Items # 11 & 12
MCPB 04-21-05

MEMORANDUM

REVIEW TYPE: **Preliminary and Site Plan Review**
CASE #: **1-89044A and 8-05027**
PROJECT NAME: **Darnestown Village Center**
APPLYING FOR: **Amendment to approved preliminary plan #1-89044 to permit 43,256 square feet of grocery use (change from previous 43,256 square feet of retail which included 33,798 square feet of grocery and 9,458 square feet of general retail); and, Approval of 10,181 square feet of additional grocery store use and waiver to the parking requirements in the C-1 Zone in Darnestown, Maryland**
REVIEW BASIS: **Div. 59-D-3 of Montgomery County Zoning Ordinance**
ZONE: **C-1, Rural Village Overlay Zone**
LOCATION: **In the northeastern quadrant of the intersection of Darnestown Road and Seneca Road, approximately 200 feet northeast of Eden Rock Court**
MASTER PLAN: **Potomac Master Plan**
APPLICANT: **Landow Co.**
FILING DATE: **February 14, 2005**
HEARING DATE: **April 21, 2005**

Proposed front elevation of the store

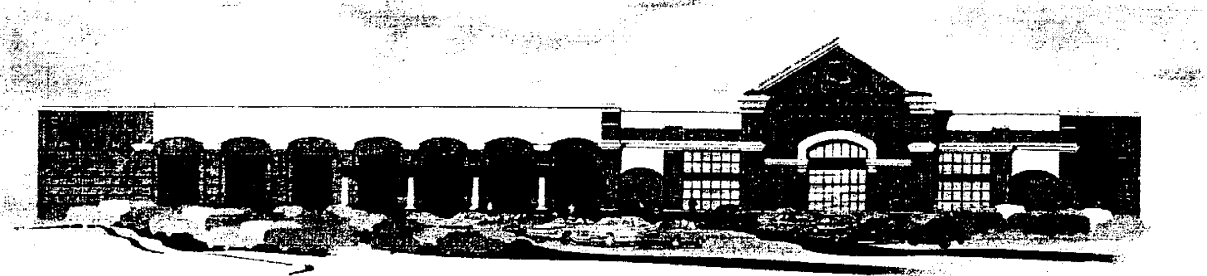
The existing Food Lion store proposes to increase the existing 33,798 square foot grocery store by 10,181 square feet, which will equal the 43,256 square feet originally approved by the preliminary plan (#1-89044) in 1989. The grocery store addition is proposed for the northeast side of the existing building in the area presently used for storage.
